**Private Plan Change 71: Four
Stars Development Ltd and
Gould Developments Ltd**

Transportation Hearing
Report

SUMMARY OF MY PEER REVIEW

Figure 4: Rolleston ODP Area 5 (proposed)

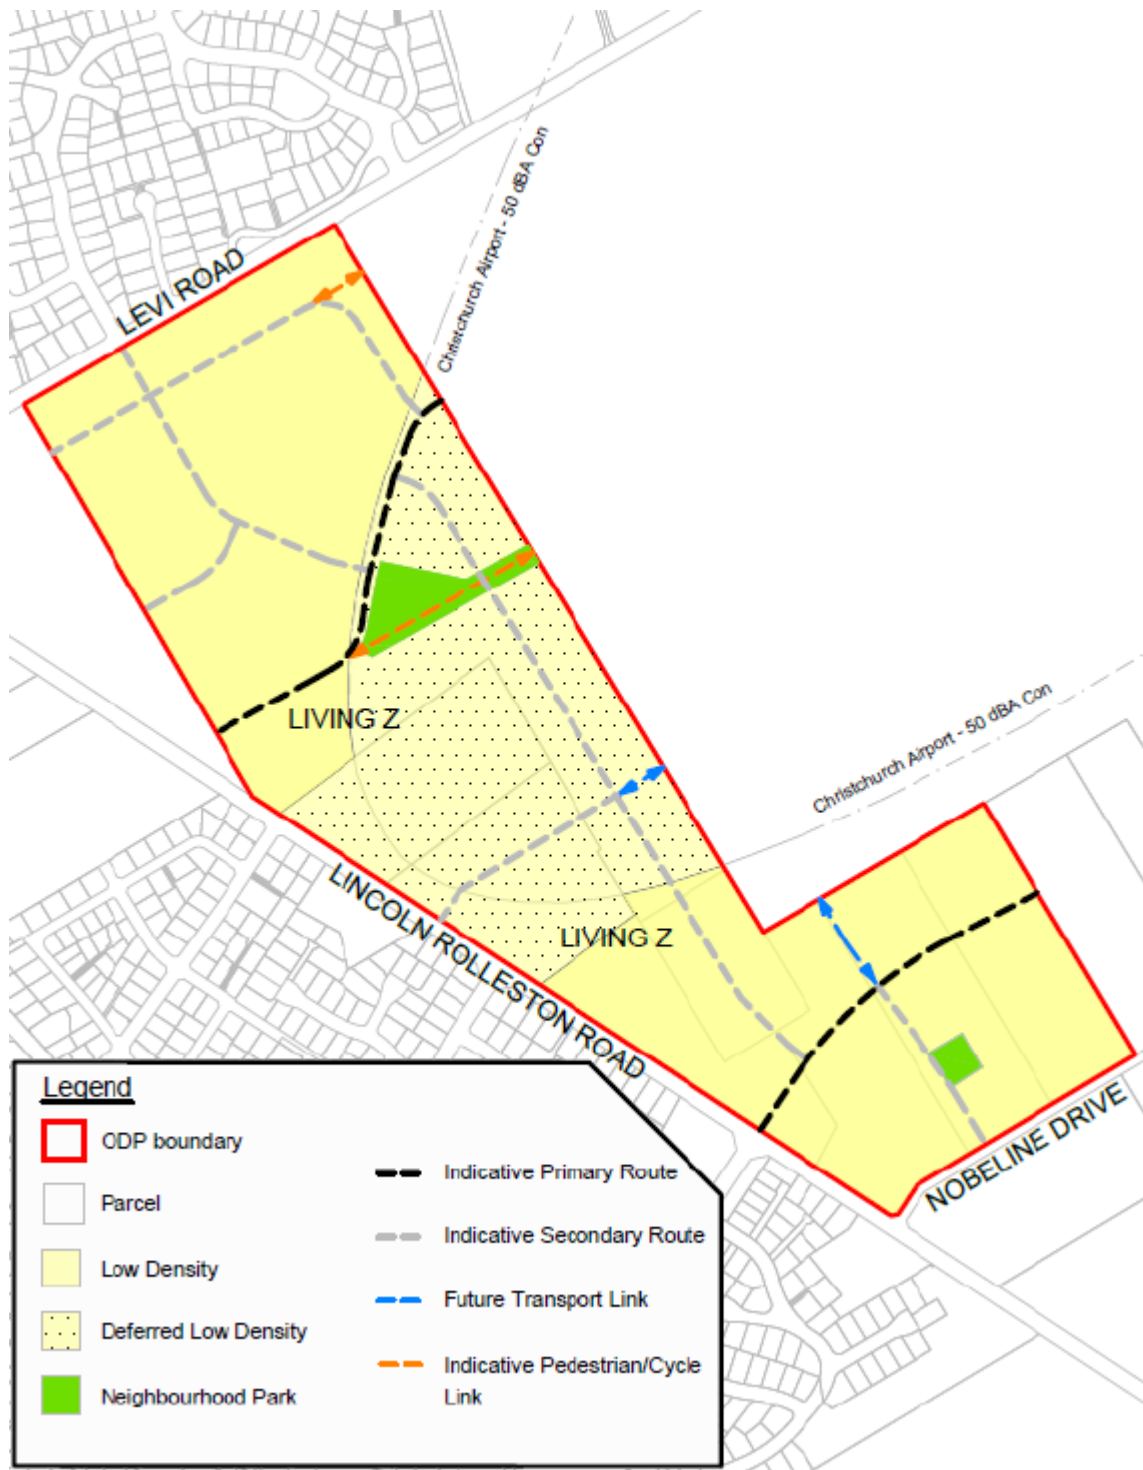
The ODP includes an area of deferred low density development, which generally sits within the Christchurch Airport noise contour, as shown in Figure 4. In my view

- ♦ Delaying development is unlikely to affect peak hour traffic distribution, as development within the southern portion of the site will tend to favour Branthwaite Drive extension over Ruby Drive extension or Broadlands Drive extension, regardless of whether internal roads provide connections within ODP Area 5

Figure 6: Indicative alignment of Broadlands Drive through ODP11

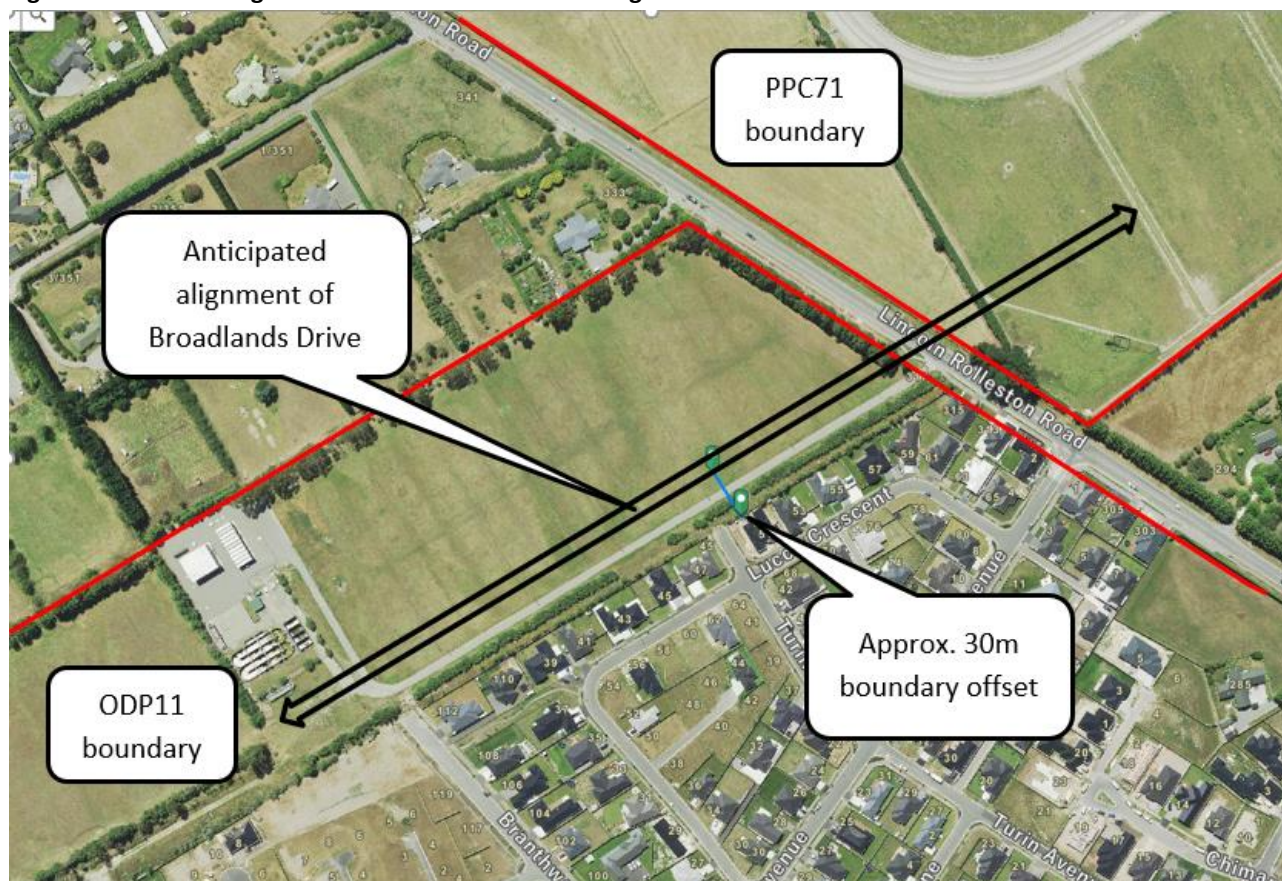
Lucca Cres (as shown in Figure 2). However, I understand that Council anticipates that this will be set approximately 30m to the north of these properties, as indicated in Figure 6. It appears that ODP Area 4 allows for this alignment, therefore I consider that the slight offset of Broadlands Drive between ODP Area 11 and ODP Area 4 reflects Council's thinking. I understand that Council anticipates forming the western section of Broadlands Drive, through ODP Area 11, in 2033/34.

I recommend that a planning mechanism is included, which identifies the need to provide the Lincoln Rolleston Road/Broadlands Drive roundabout and Broadlands Drive extension to align with development within ODP Area 5. Pending confirmation from the applicant regarding my recommendations for the Levi Road/Ruby Drive intersection (discussed in Section 5.3), I have left a placeholder "xxx" for staging in my recommended wording as follows

Figure 7: Comparison of operative and proposed ODP Area 4

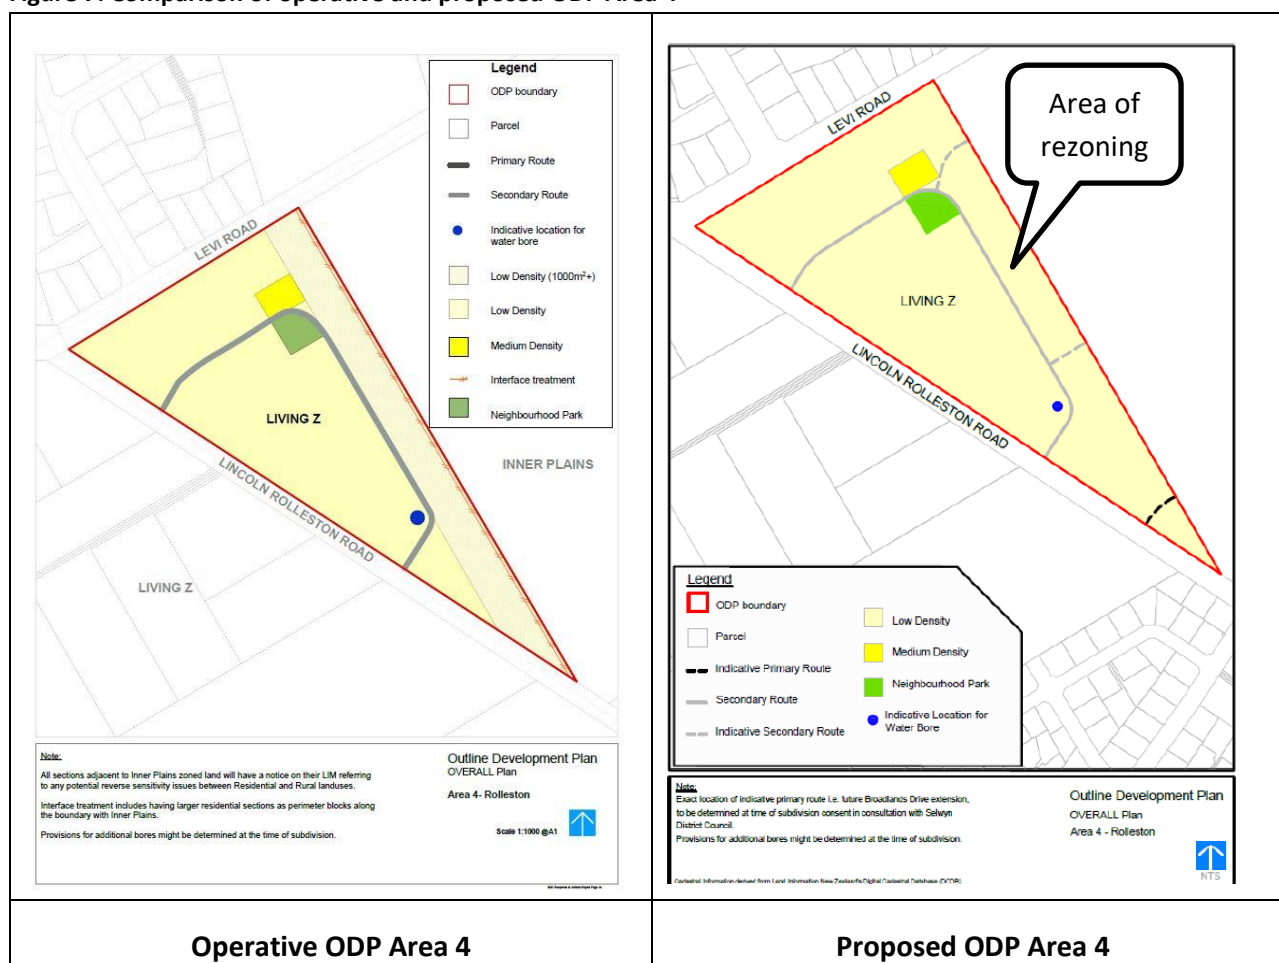
Included in PPC71 are proposed amendments to the operative ODP Area 4. Changes are shown in Figure 7 and include

- ◆ Two "indicative secondary routes" to connection to ODP Area 5
- ◆ One "indicative primary route" to form the extension of Broadlands Drive between Lincoln Rolleston Road and ODP Area 5
- ◆ Change from low density (1000 m² +) to low density.

I consider that omission of this area from the ITA assessment has a negligible effect on my assessment of PPC71, or the conclusions of my report.

Outcome: The ITA does not appear to consider the potential effects resulting from rezoning land within Area 4 from low density (1000 m²+) to low density. I have assessed the potential increase in yield that may result and estimate this to be approximately 4 dwellings. I consider that this omission has a negligible effect on my assessment of PPC71, or the conclusions of my report.

...it is anticipated that the built standard for a —Primary Road will be the equivalent to the District Plan standards for a Collector Road ~~or Local-Major Road~~ standards, and a —Secondary Road will be the equivalent to the District Plan standards for a Local-Major or Local-Intermediate Road, subject to confirmation of compliance to Council’s Engineering requirements”

...A new primary road link in the form of an extension of Broadlands Drive will cross the southern part of the ODP Area to connect up with the Plan Change 71 site providing direct east-west access to the proposed District Park. The intersection of Broadlands Drive with Lincoln Rolleston Road shall be formed as a roundabout.”

Figure 8: Rolleston Structure Plan with PPC71 location

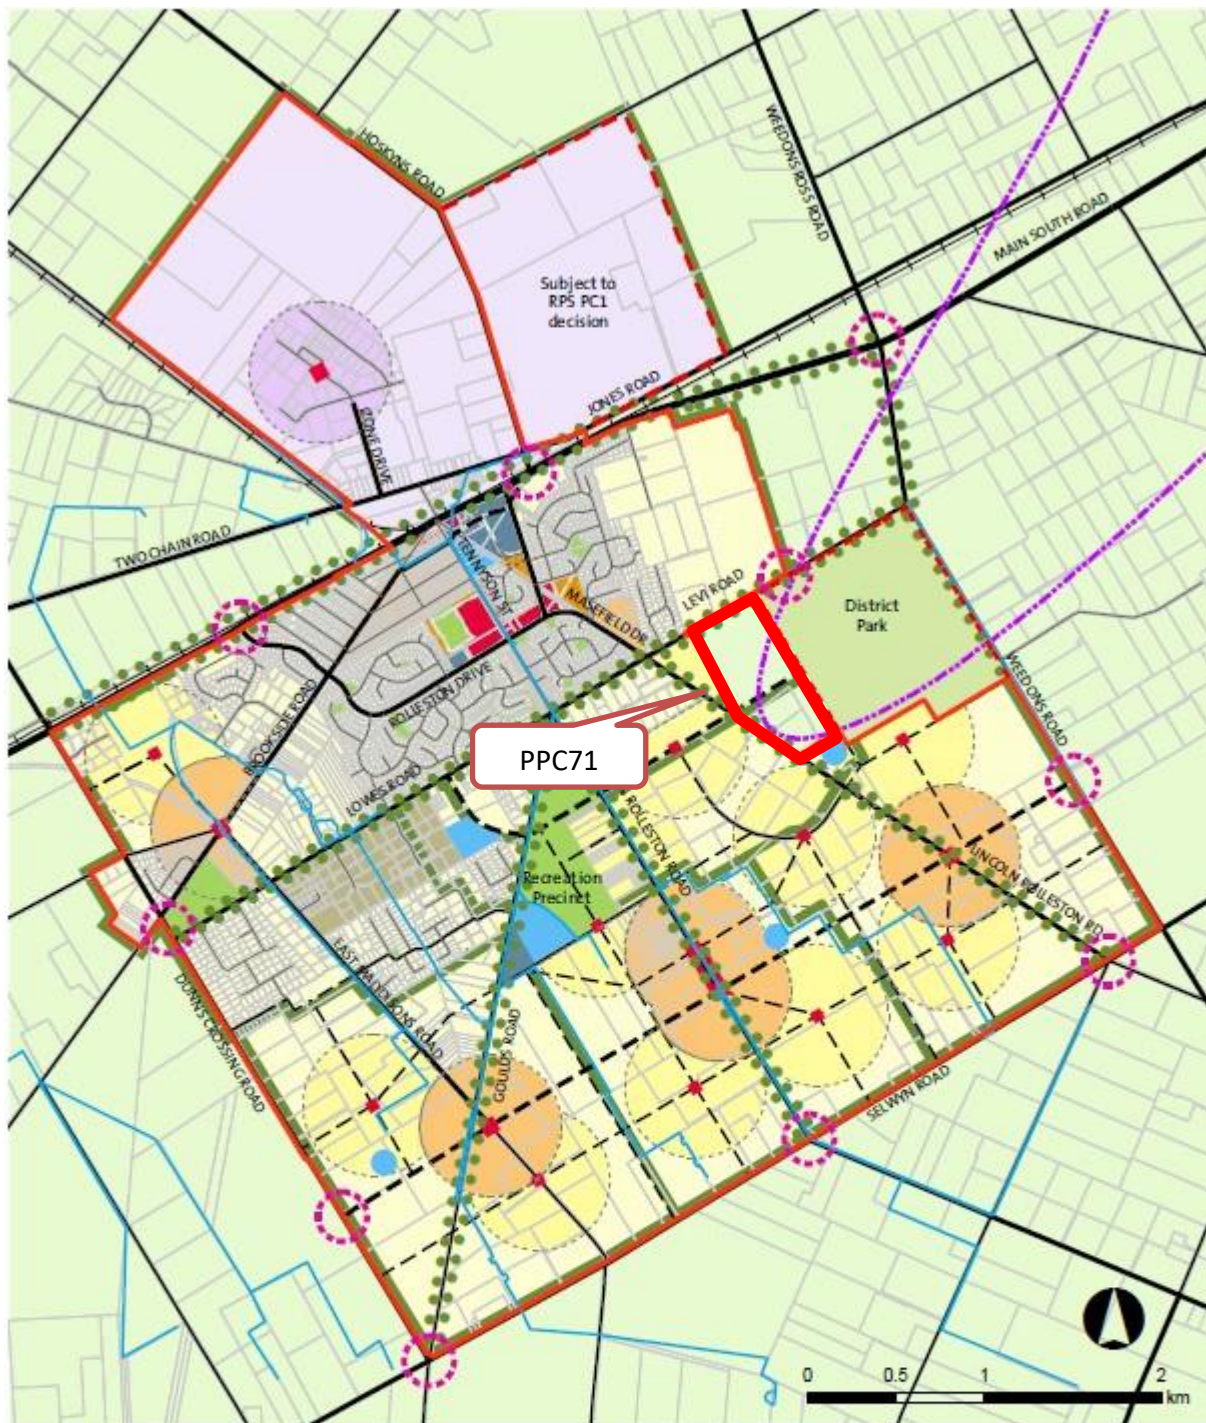
PPC71 sits outside of the anticipated urban area, as shown in Figure 8, as well as the proposed infrastructure boundary specified in the Canterbury Regional Policy Statement (CRPS) Map A. The transport effects of PPC71, and other PPCs within Rolleston, have been assessed for the local transport network (as discussed in Section 4).

Outcome: PPC71 is inconsistent with the Rolleston Structure Plan, in that it is outside the anticipated urban area. Should PPC71 affect the quantum of residential growth within Selwyn, without a corresponding increase in local employment and access to services, additional impact on the Greater Christchurch transport network can be expected as additional residents in Selwyn travel to access services and employment. However, assessing the effects of such development on the long term planning and funding commitments associated with bulk transport infrastructure is complex and requires assessment of multiple land use scenarios.
